TITLE - DOOR AUTOMATION

DWG NO - NTPL- 300-PM-01

PRODUCT - GEAR OPERATED SHUTTER
PROJECT NO - NTPL- 300 | REVISION - 01
SITE LOCATION-GUJARAT | WEIGHT - 31 kg
MATERIAL - MS | QTY - 04 NOS
IF ANY QUERIES CONTACT - Design@nihva.com | PROJECTION METHOD | SCALE :
ALL DIMENSIONS ARE IN 'MM' | A2 | SHEET 1 OF 1

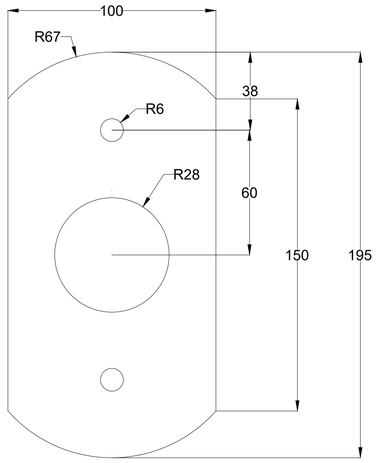
| RIVISION. | DATE |
|---|---|
| REV 01 : SLAT THICKNESS CHANGE 1MM TO 1.2MM<br>BOTTOM PLATE THICKNESS CHANGE 2.5MM TO 3.15MM<br>ANGLE STIFFENER CHANGE 35X35X3 MM TO 35X35X5 MM | 03-12-2025 |
